BELLEFONTE COMBINED LICENSE APPLICATION – RELATED TO RAW WATER SYSTEM FOR THE BELLEFONTE UNITS 3 AND 4 COMBINED LICENSE APPLICATION

Reference: Letter from Tanya Simms (NRC) to Andrea L Sterdis (TVA), Request for Additional Information Letter No. 144 Related to SRP Section 09.02.01 for the Bellefonte Units 3 and 4 Combined License Application, dated January 28, 2009.

Subject: Station Service Water System, Application Section: 9.2.11 Raw Water

Attachment 09.02.01-06B
FSAR Figure 9.2-201
Revised FSAR Figure 9.2-201 (Sheet 1)
(3 pages including the cover sheet)

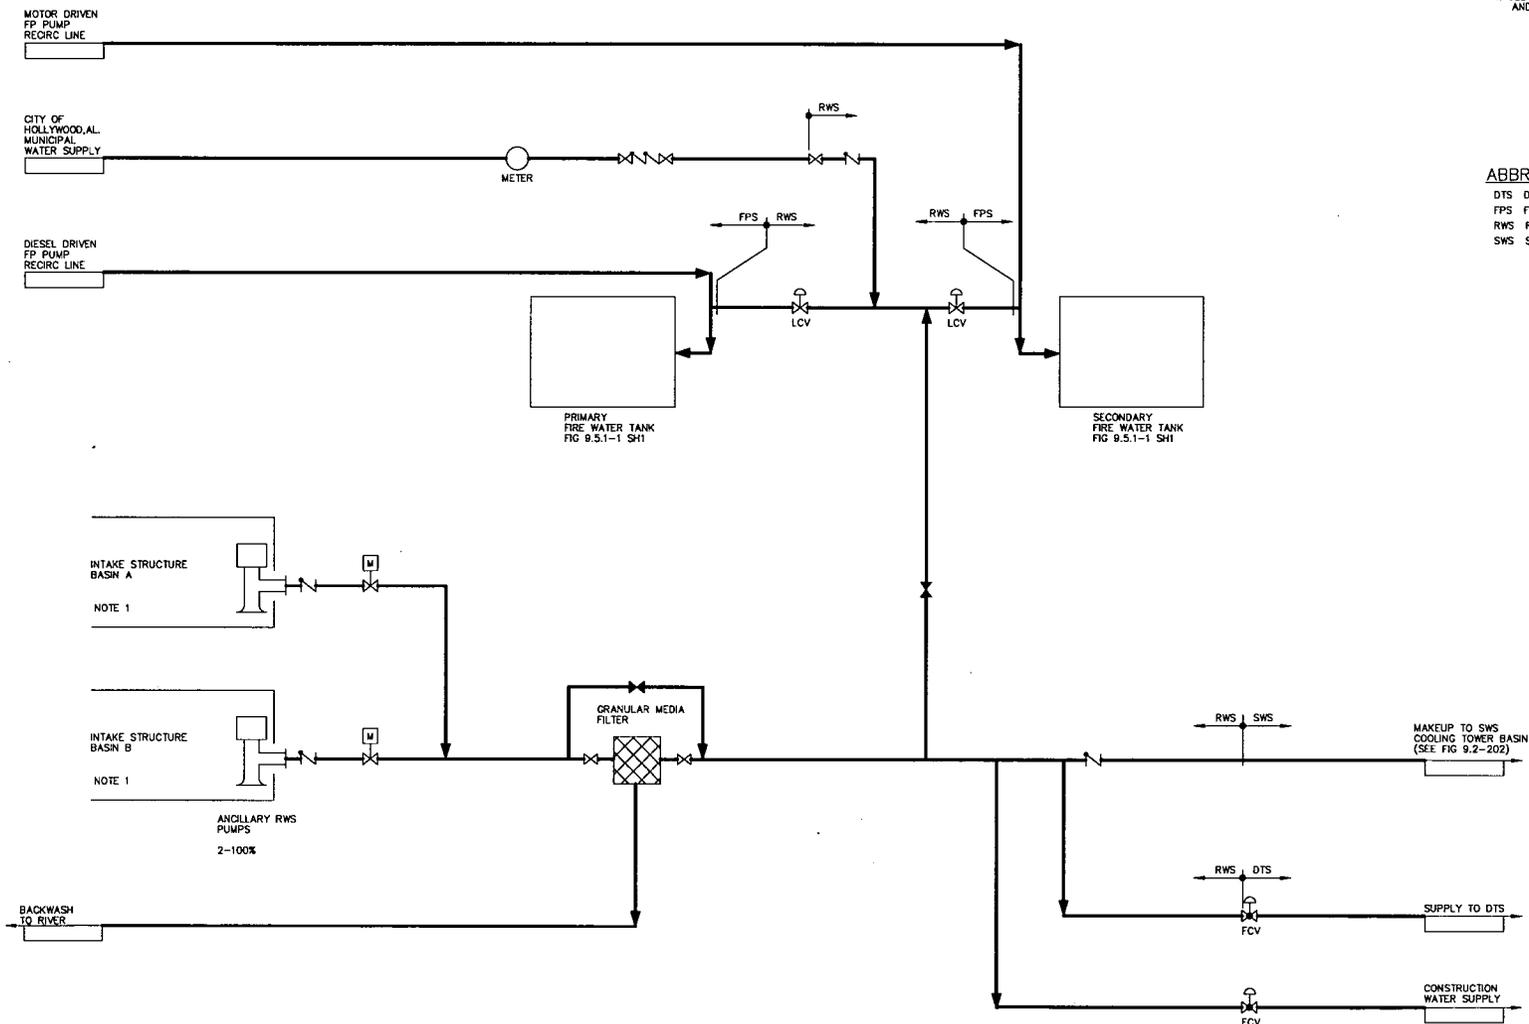
The RWS piping connection to the fire water storage tanks is via a normally closed manual isolation valve as shown on FSAR Figure 9.2-201 (Attachment 09.02.01-06B). The effects of the failure of RWS piping connection to fire water storage tank is enveloped by the CWS piping break in the yard as described above.

RWS piping is routed inside the Turbine Building to the interface points with SWS, TCS and DTS. The RWS piping connections are shown on FSAR Figure 9.2-201. These connections are located above the floor of the turbine building at DCD elevation 100'-0". The RWS-to-DTS interface is upstream of the DTS filters and DTS feed pumps. The primary source of flooding from a break in the RWS piping would be limited to the time when the RWS pumps are running and would be terminated upon shutdown of these pumps. As discussed in DCD Subsections 3.4.1.2 and 10.4.5.2.3, the bounding flood is due to a break in the circulating water system. Water from a postulated system rupture above elevation 100'-0" would travel to elevation 100'-0" through floor gratings and stairwells and would run out of the building through a relief panel in the turbine building west wall. This relief panel limits the maximum flood level to less than 6 inches, which is not high enough to cause damage.

The RWS piping connection to the TCS has a normally closed valve as shown on FSAR Figure 9.2-201. Due to the size of the system piping, flooding of the turbine building resulting from a break in the RWS is less severe than flooding resulting from a break in the CWS.

2. COLA Part 2, FSAR Chapter 9, Figure 9.2.1-201 (Sheet 1 of 2) will be replaced with the figure provided in Attachment 09.02.01-06B.

h.	Revised FSAR Subsection 9.2.11, Figures 9.2-201, Sheet 1 & 2 and 9.2-202	FSAR Figure 9.2-201, Sheet 1&2 and Figure 9.2-202 show the appropriate RWS system piping connections and appropriate interface breaks at proper locations. Division designations are not shown on the RWS flow diagrams . The RWS is non-divisional.
